PLANNING COMMISSION MEETING STAFF REPORT

NAME OF PROJECT: The Farm at Wilson Lane

AGENDA ITEM: Concept Plan Review

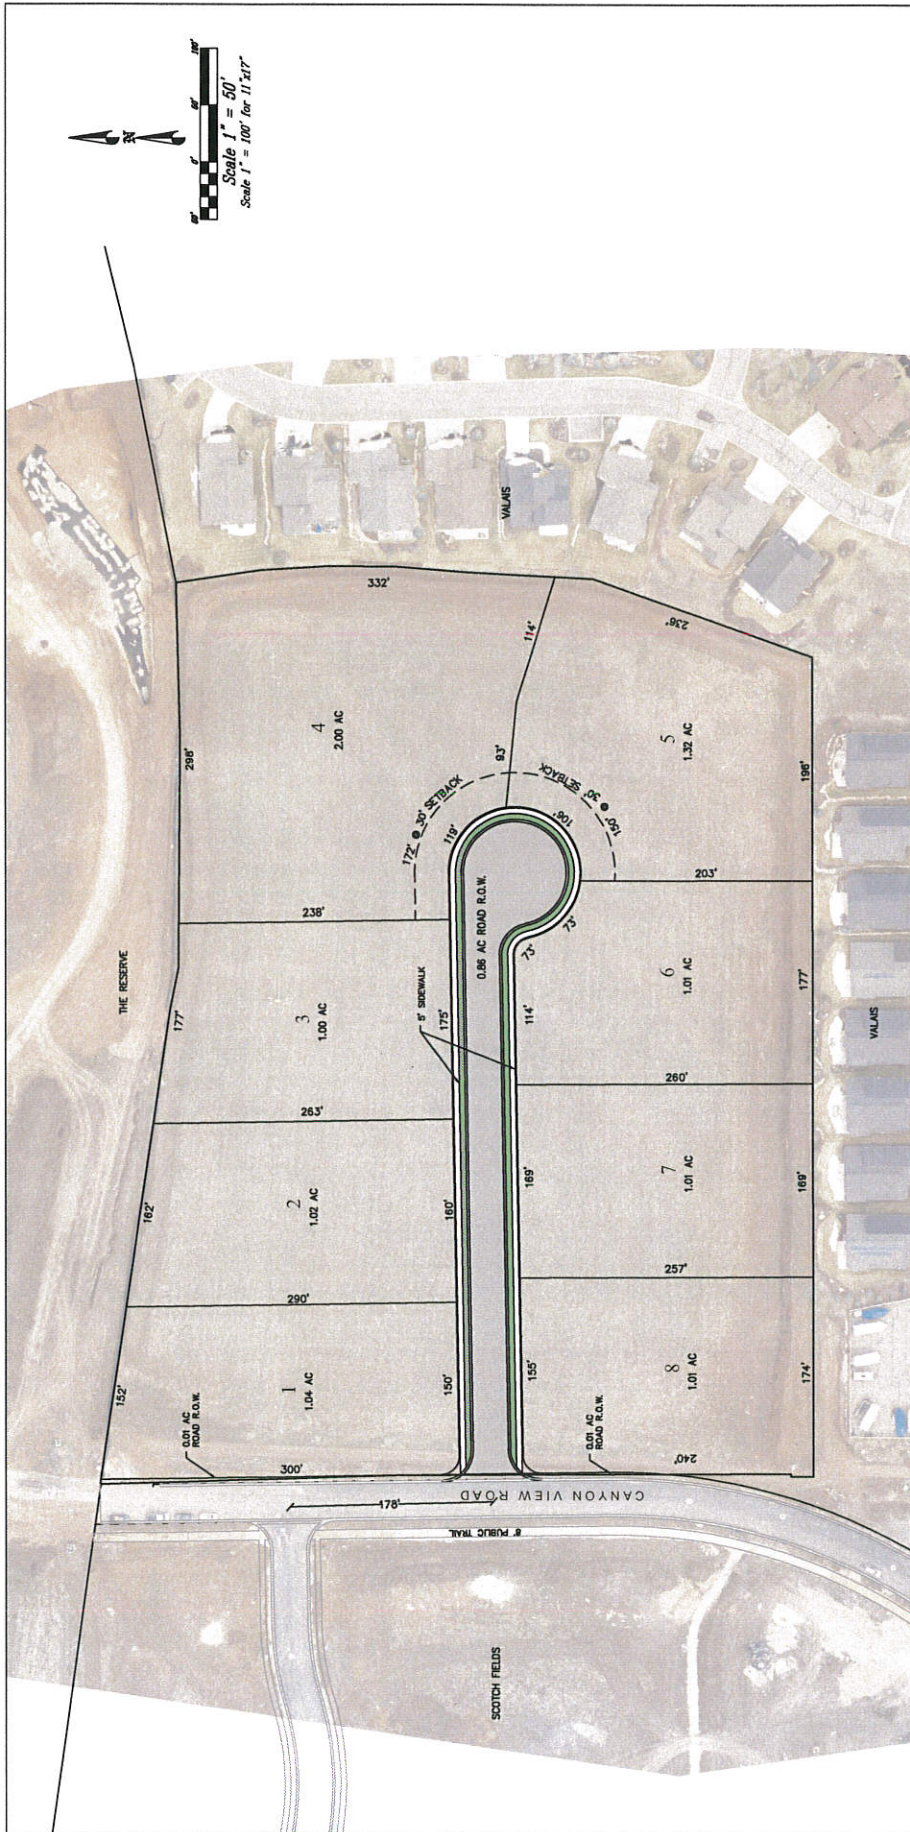
The existing parcel is surrounded on all four sides by existing, platted subdivisions (Valais, Scotch Fields, and The Reserve at Midway) that are at various stages of build out. The proposed plan consists of eight lots. The lots all appear to meet the minimum frontage and acreage needed to comply with the requirements of the RA-1-43 zone. The

existing parcel is accessed from Canyon View Road. The proposal shows access into the property coming from a newly constructed cul-de-sac road that would create frontages for all eight proposed lots.

The proposed cul-de-sac road meets the minimum road centerline offset of 150' from Jerry Gertsch Lane in Scotch Fields. The proposal also complies with the cul-de-sac maximum length of 1,300' and maximum lot count on a cul-de-sac of eleven.

Standard subdivisions greater than 10 acres in size are required to provide a minimum of 15% open space. The applicant has elected to incorporate the required open space into lot four, which is allowed if the lot size is a minimum of two acres, which it is. The applicant will need to identify which portion of the lot counts towards the required open space and will need to include a note that limits uses as well as excluding the construction of any structures on the open space area.

The applicant will need to provide a pedestrian connection along Canyon View Road or install ADA ramps adjacent to the development allowing for a connection into the existing trail on the west side of Canyon View Road.

The applicant will be required to dedicate their portion of the right-of-way needed for Canyon View Road.
